**REVIEW OF REVISED SHELTER-IN-PLACE PLAN FOR THE MUSLIM SCHOOL
IN SANTA CLARA, CA**

Ramboll US Consulting, Inc. (Ramboll) has prepared this letter report to summarize our review of the revised Shelter-in-Place (SIP) Plan for the Muslim Community Association's (MCA's) Muslim School and associated religious facilities located at 3003 Scott Boulevard and 3080 Alfred Street in Santa Clara, California (the "Site").

Ramboll understands that the revised SIP Plan for the MCA campus is comprised of seven diagrams (see Appendix B), which are summarized below:

SIP-201

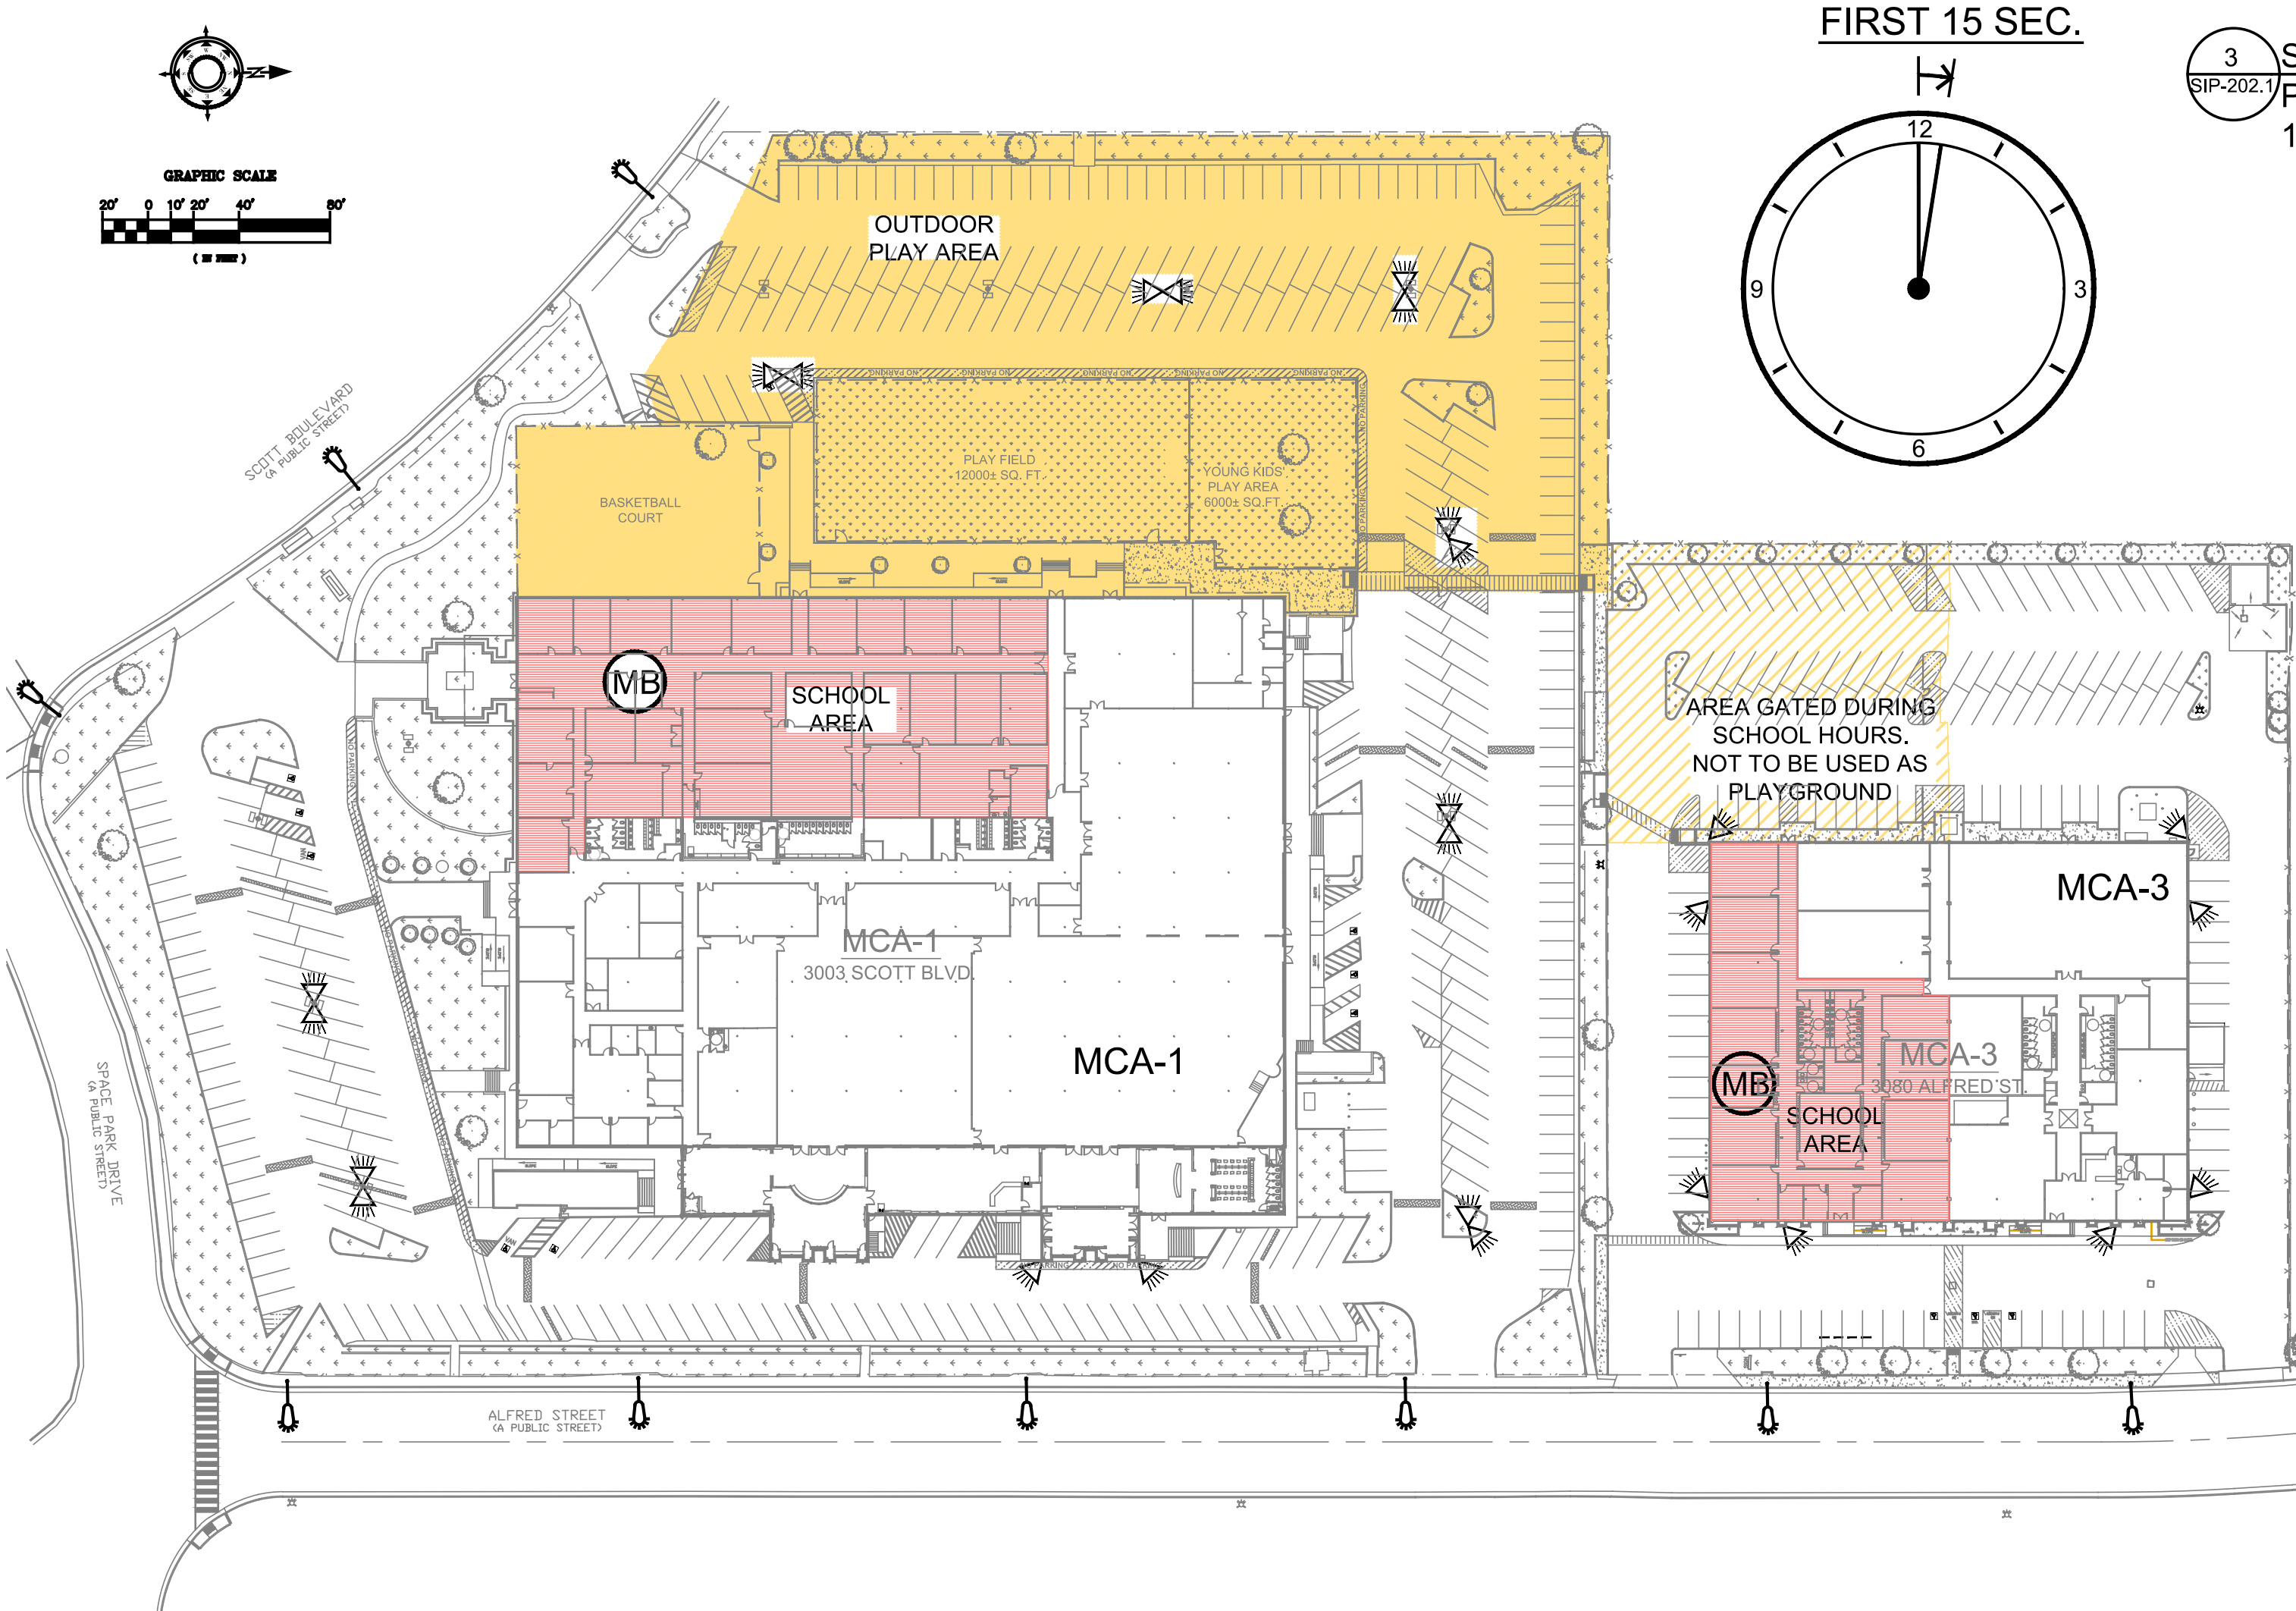
- The revised SIP Plan's response preparation measures are consistent with local, state and federal and aid organization guidance.
- Consistent with guidance, the stated purpose of the current SIP Plan designates only interior classrooms as SIP areas. The revised SIP Plan (Objective 2 of "Objectives of Shelter In Place Program" [i.e., Section SIP-202.1 on Sheet SIP-202.1]) states that "Shelter in place classrooms are the innermost classrooms, furthest from outdoors and windows, if possible." Ramboll noted that classrooms with outside windows were specifically designated as non-SIP locations (i.e., SIP-201).

- Ramboll noticed that the Designated Students Assembly Area in MCA-3 is not labelled in the SIP procedure document. It is not clear what room/area this is (e.g., cafeteria, gym, etc.). Ramboll recommends labelling the location of the Designated Students Assembly Area in MCA-3 on the Shelter-In-Place diagram that is to be posted in each room to be clearer in the event of an emergency.

- Ramboll noticed that MCA-3 School SIP Command Center room is also not labelled in the SIP procedure(e.g., cafeteria, gym, etc.). Ramboll recommends that MCA label the name of the room that will be used as the SIP Command Center in MCA-3 on the Shelter-In-Place diagram that is to be posted in each room to be clearer in the event on an emergency.
